The Town of Hilton Head Island Regular Design Review Board Meeting

AGENDA

DESIGN TEAM/ DRB COMMENT SHEET

PROJECT Ocean Walk Villas Phasing Plan DRB# DR070089

Phasing Plan
SP101

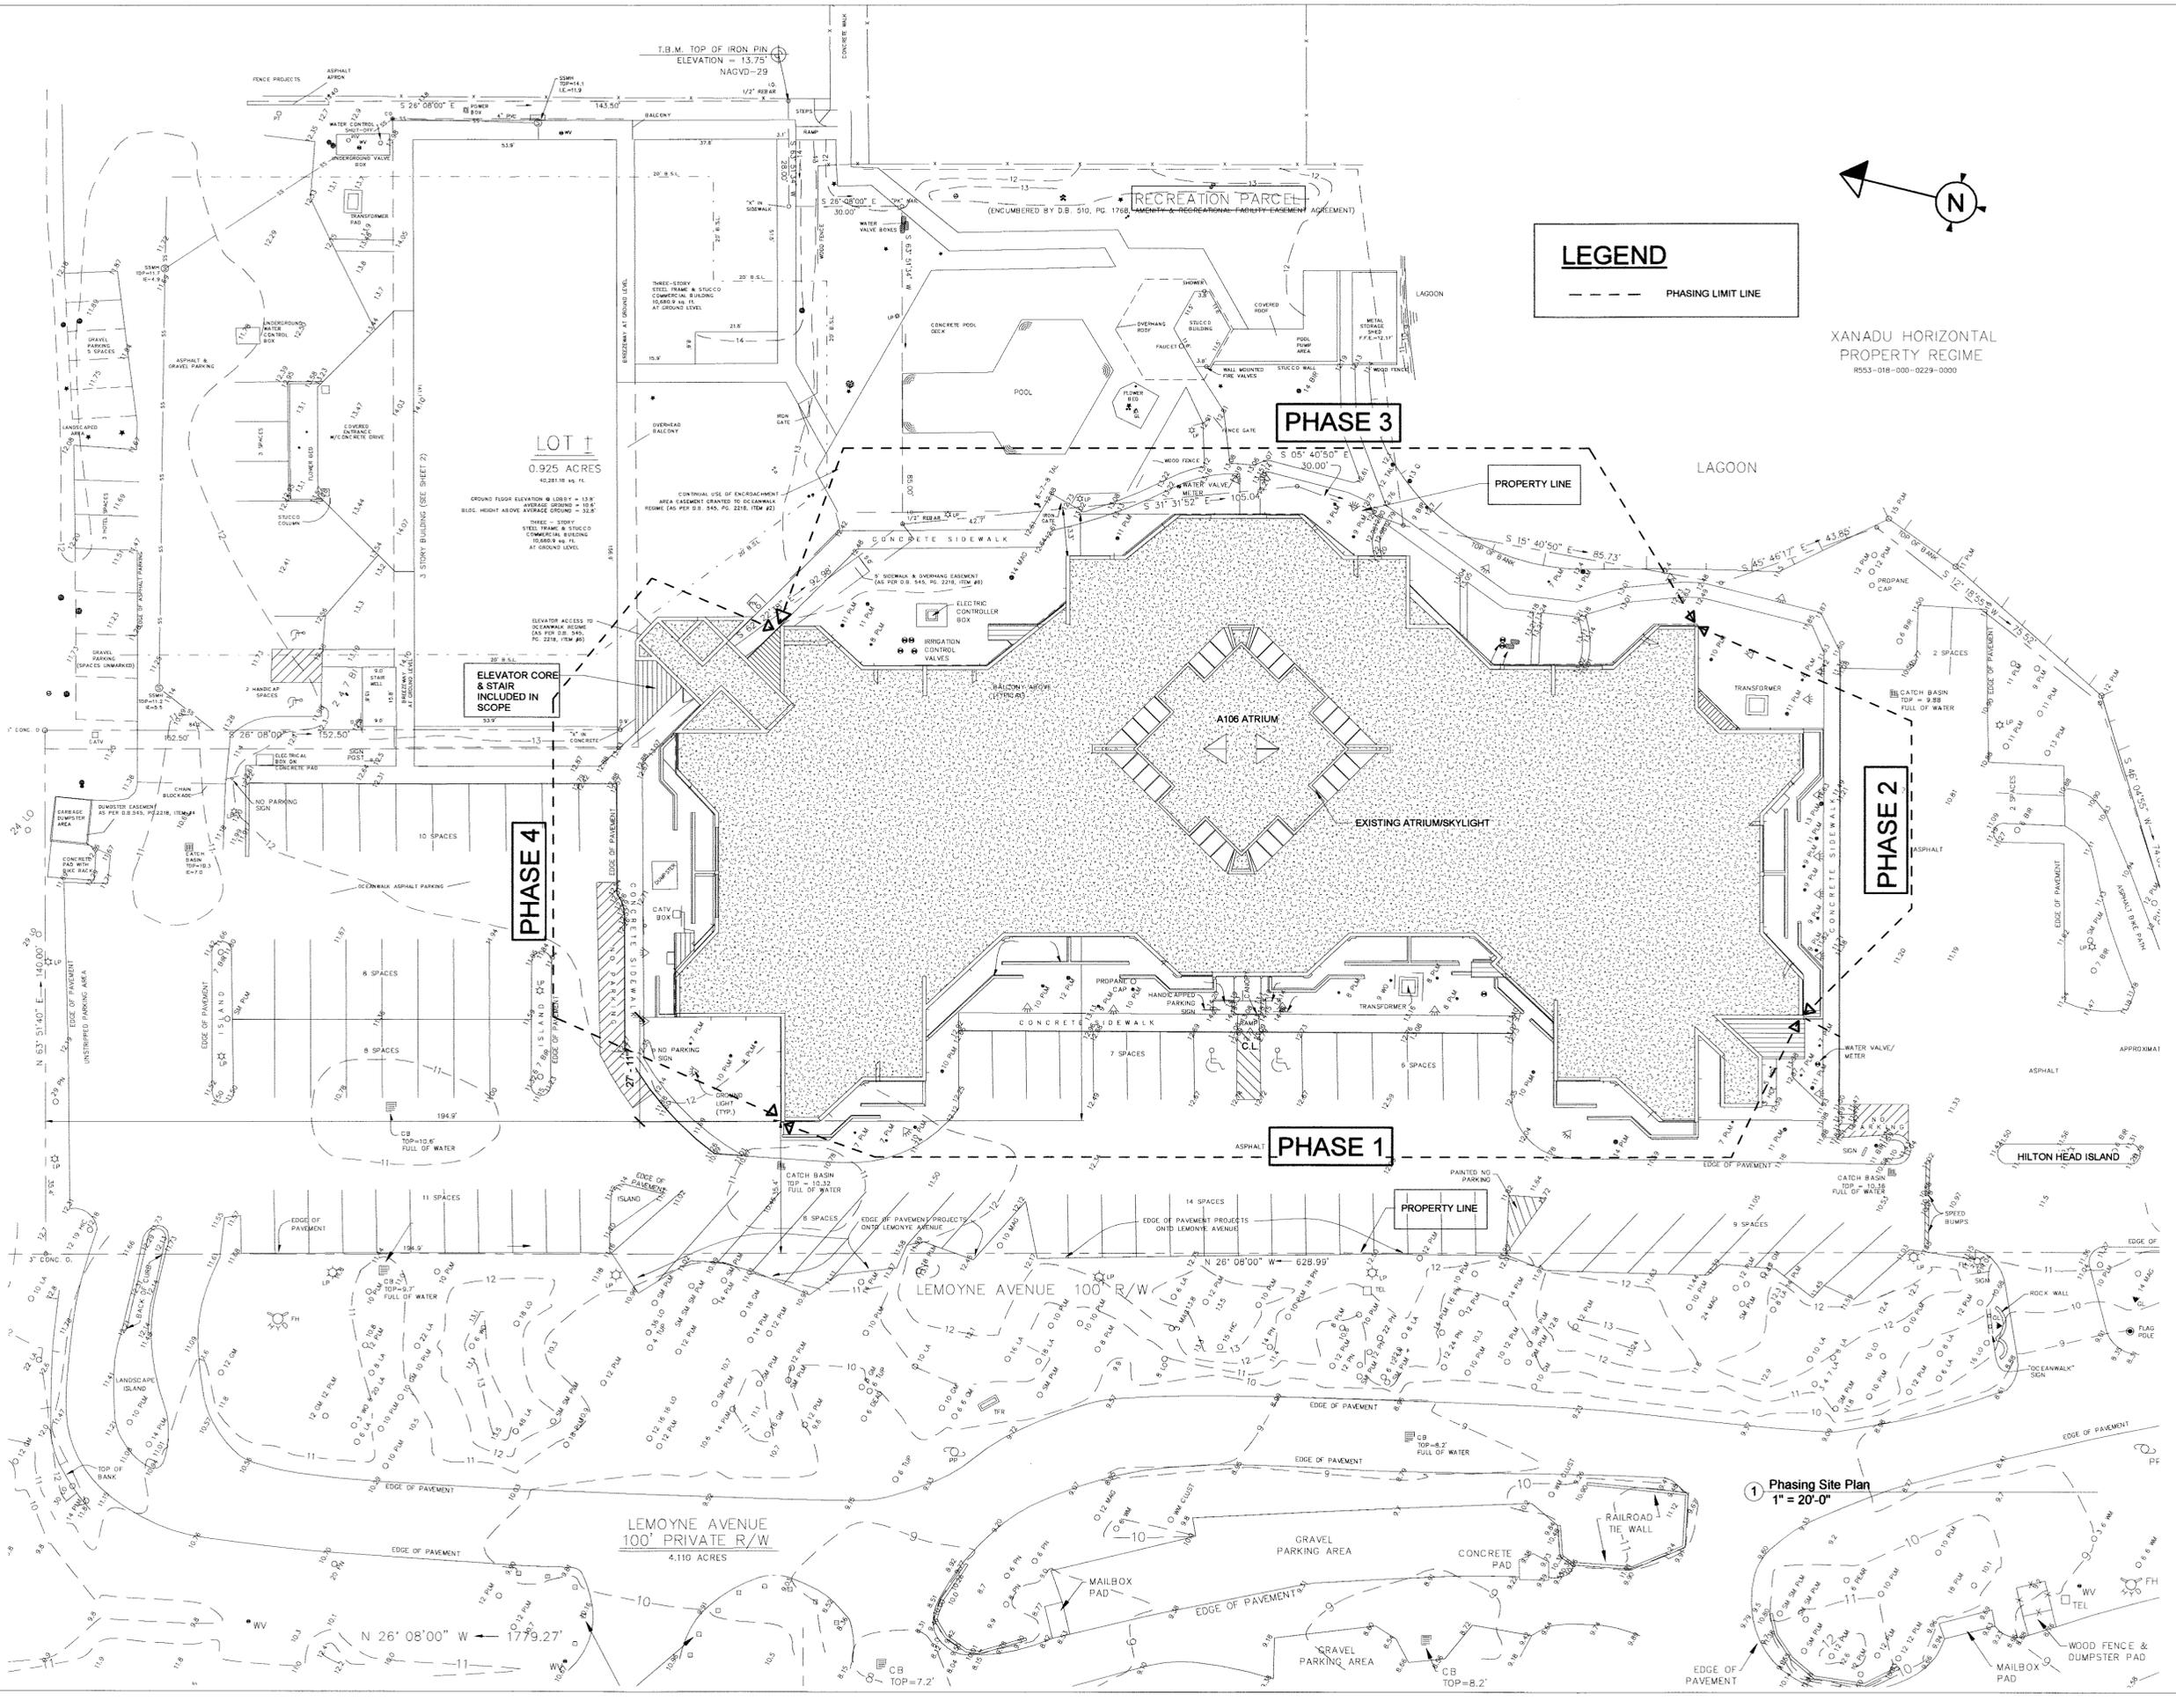
Contemplates phasing each side of the building over a three year period. Given the aggressive change in the color palette, and the historical value-engineering of the project, there is the potential for only partial completion. Even on the proposed schedule, there will be a noticeable disconnect between completed and future phases for an extended period of time

West Elevation & Dtls
A200

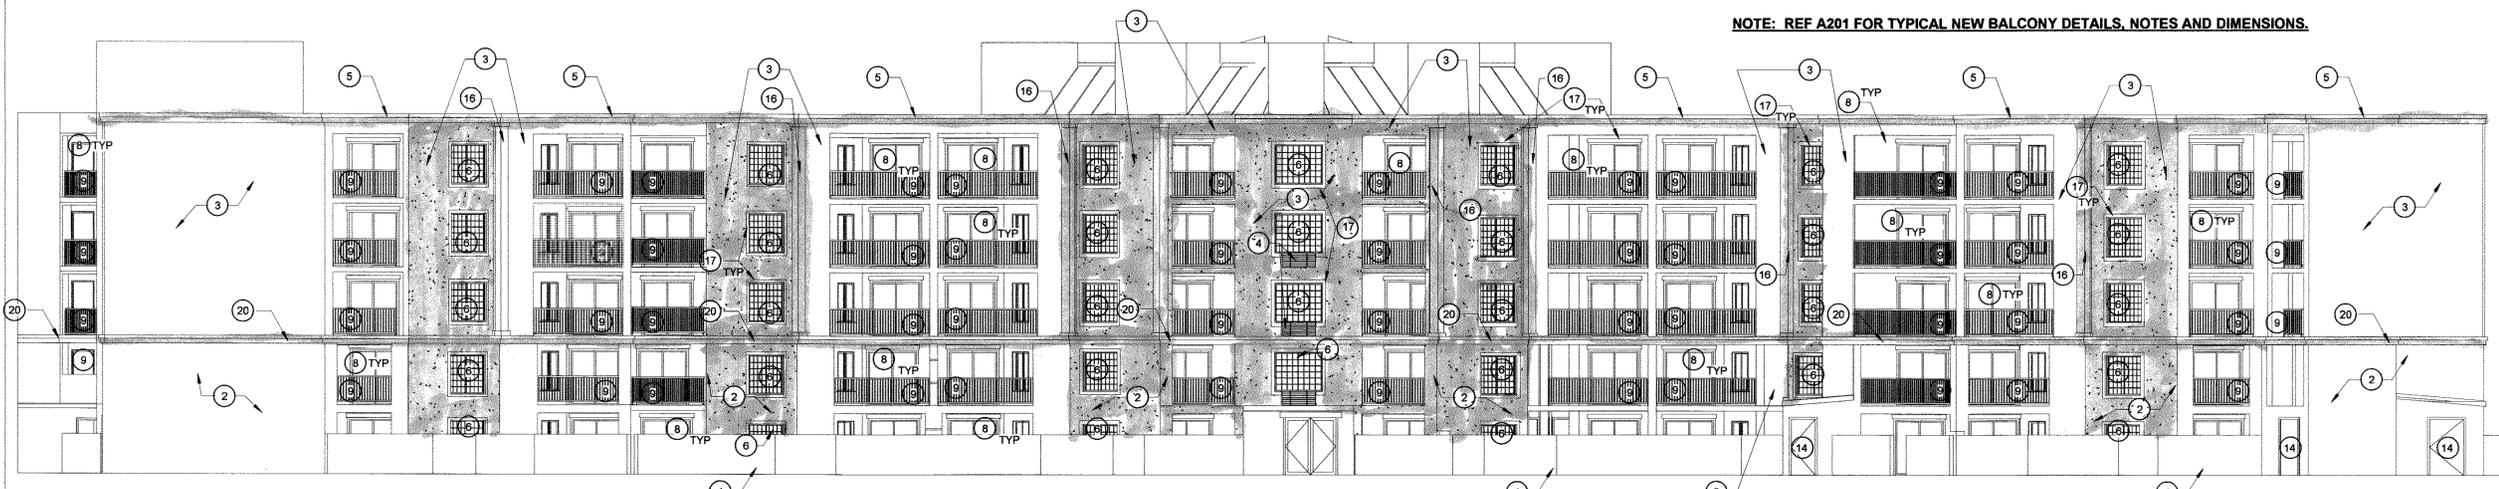
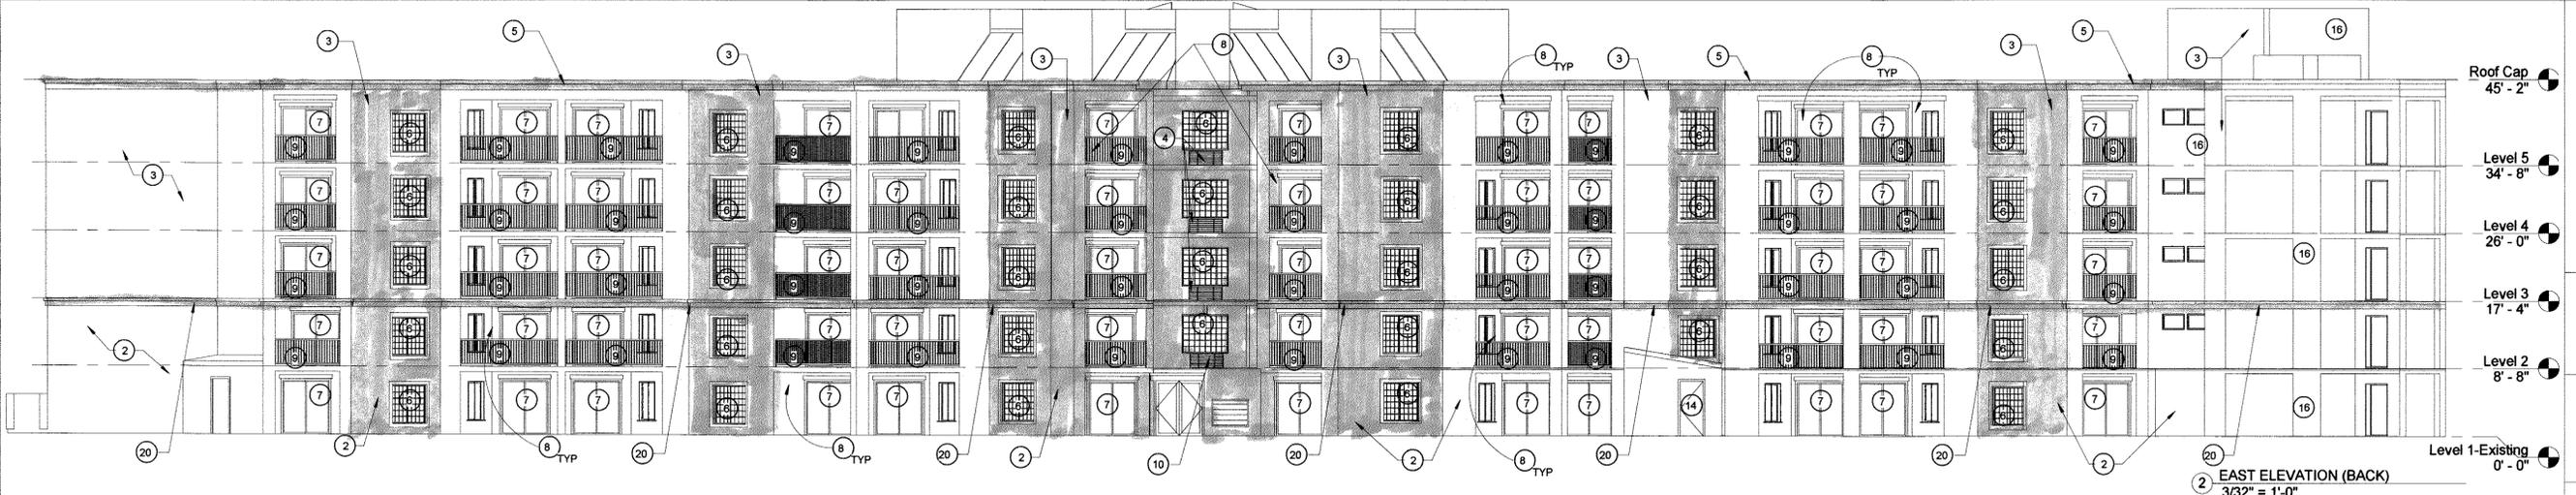
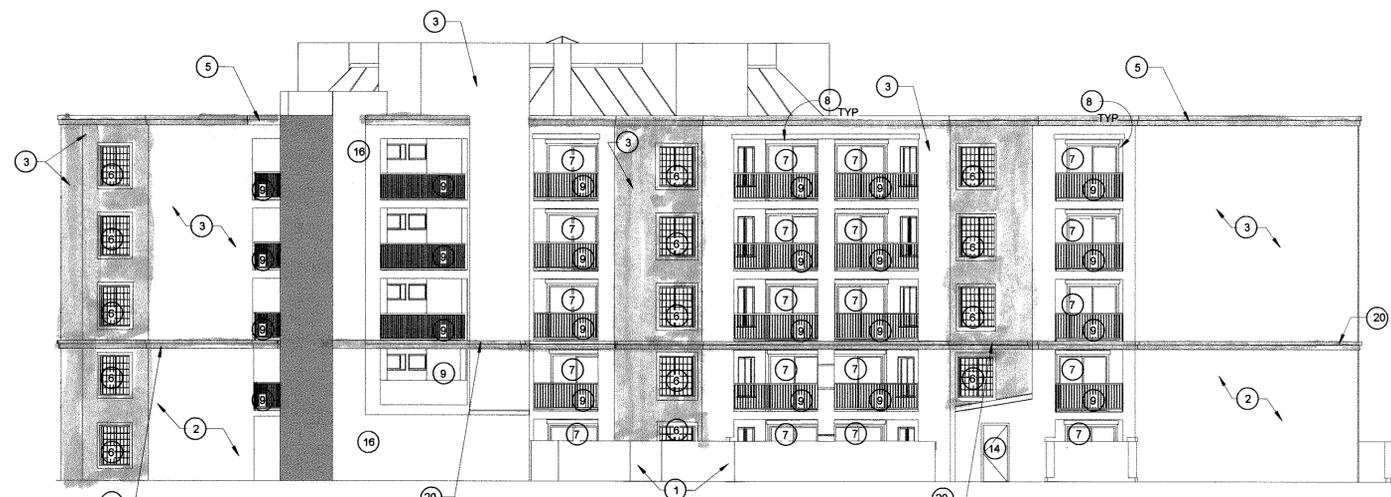
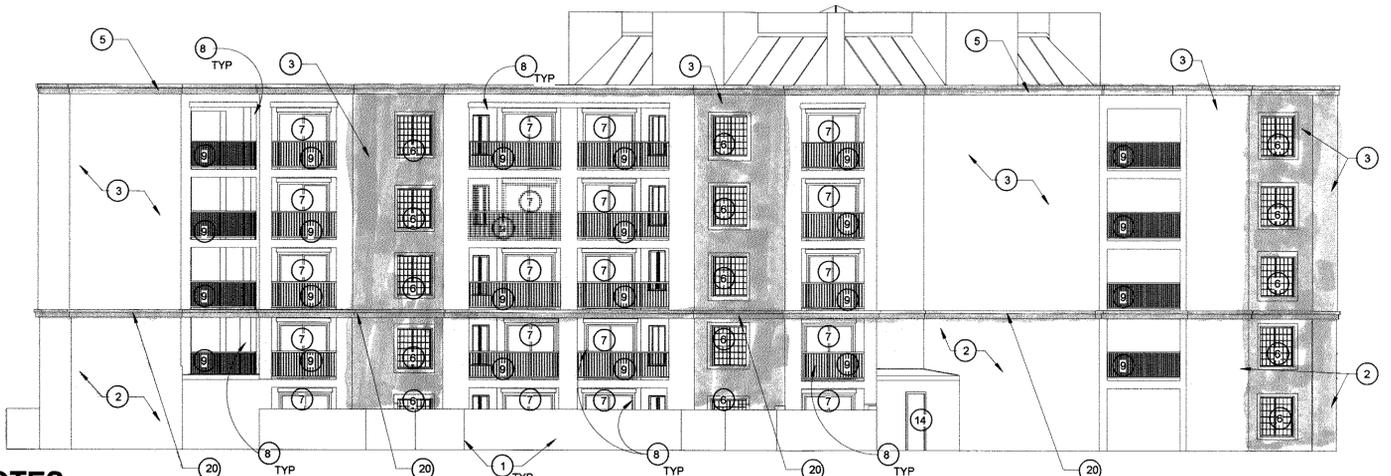
A further attempt to move forward with the improvements originally approved. Windows are replaced outside of the balcony areas, and stucco is repaired and replaced to logical existing control joints. Details and color scheme are in keeping with the original approval
